Re: Proceeding 22942 – Consultation on 12 Coincident-Peak (12 CP) Method

In response to the AESO's e-mail of March 14, 2018, and on behalf of the Dual Use Customers (DUC), we appreciate the opportunity to provide the following comments and responses to the AESO's application and the materials presented on March 12, 2018 at the AESO's offices.

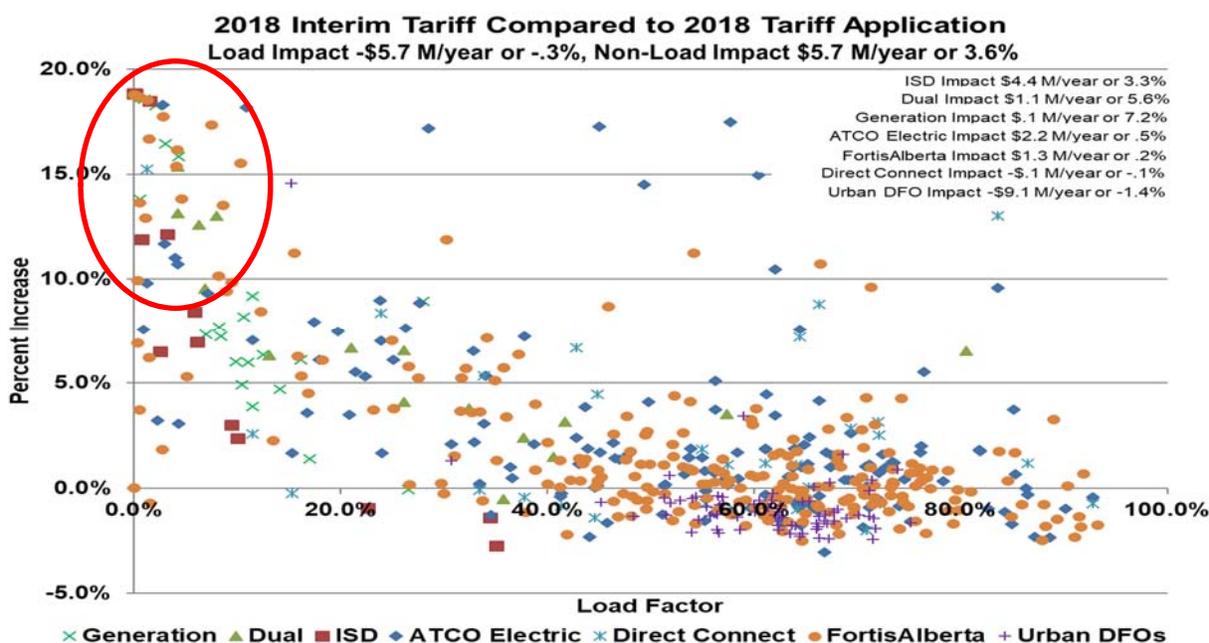
9. The AESO's proposed 2018 tariff, compared to the current 2018 interim tariff, will shift costs from high load factor customers to low factor customers (mainly generators and customers with behind-the-fence generation, Dual use and ISDs).³ The AESO is proposing rate increases to PODs supporting generation up to 18%, with all non-load PODs proposed to receive an average 3.6% increase. All load PODs in aggregate are proposed to receive a 0.3% reduction. Please see the chart below:

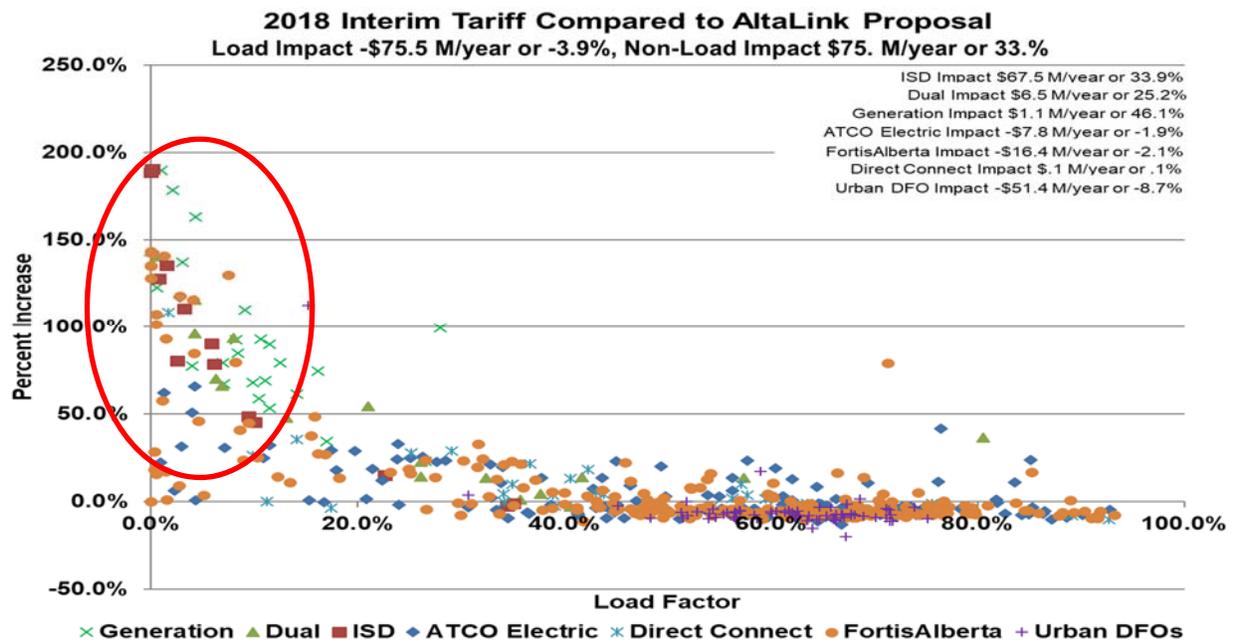
14. AltaLink’s proposal is for Bulk system demand costs to be recovered 1/3 via coincident peak (CP) demand and 2/3 via non-coincident peak (NCP) billing demand or Billing Capacity.⁸ This proposed rate design will shift \$75 million per year from load customers to non-load customers, with some ISD and Generation customers impacted by proposed rate increases up to 180%. On average, PODs supporting generation would be impacted by a 33% rate increase. Please see the chart below:

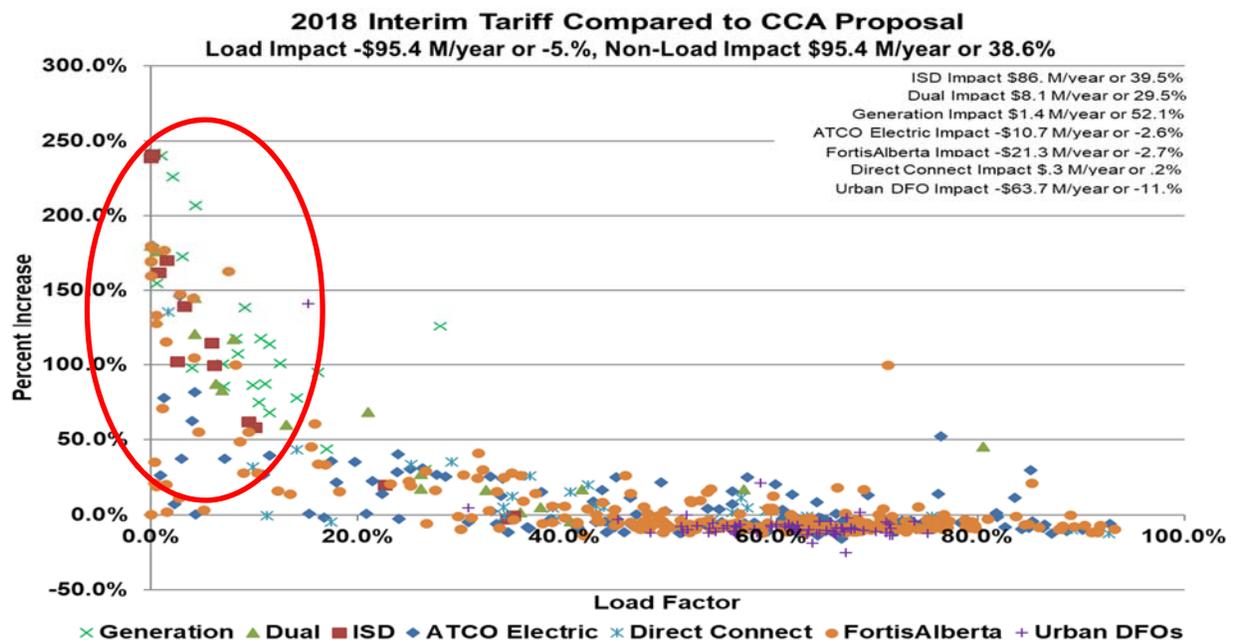
15. The CCA suggests that Bulk system cost recovery be based on the higher of CP or NCP times X%, where X is the probability of line peaks occurring at the same time as 12 CP hours (Ontario uses 85%).⁹ Using an X of 85%, the CCA proposal would shift even more costs from load to generator PODs than AltaLink’s proposal. CCA’s proposed rate design will shift \$95 million per year from load customers to non-load customers, with some ISD and Generation customers impacted by proposed rate increase of almost 250%. On average, PODs supporting generation would be impacted by a 39% rate increase. Please see the chart below:

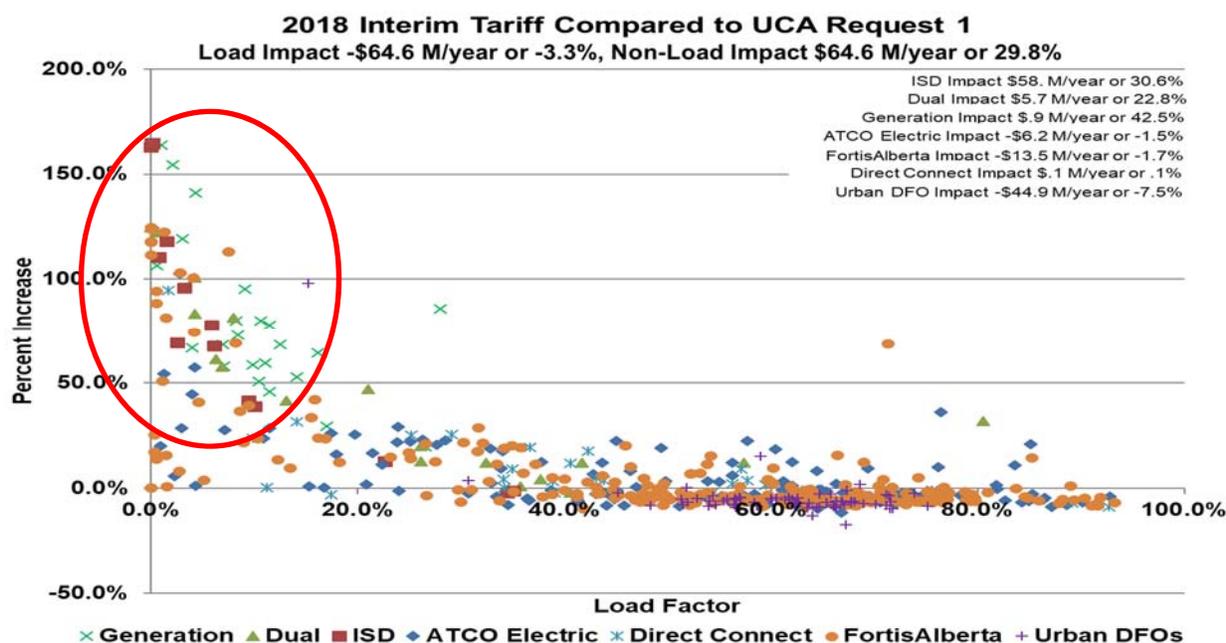
17. The UCA's first sensitively analysis requests that all 240 kV assets be defined as Regional and the resulting costs collected via NCP billing capacity determinants.¹² From the AESO's proposed cost of service study 57% of the existing and forecasted bulk costs are 240 kV.¹³ This proposed rate design will shift \$64 million per year from load customers to non-load customers, with some ISD and Generation customers impacted by proposed rate increase of 170%. On average, non-load customers would be impacted by a 30% rate increase. Please see the chart below:
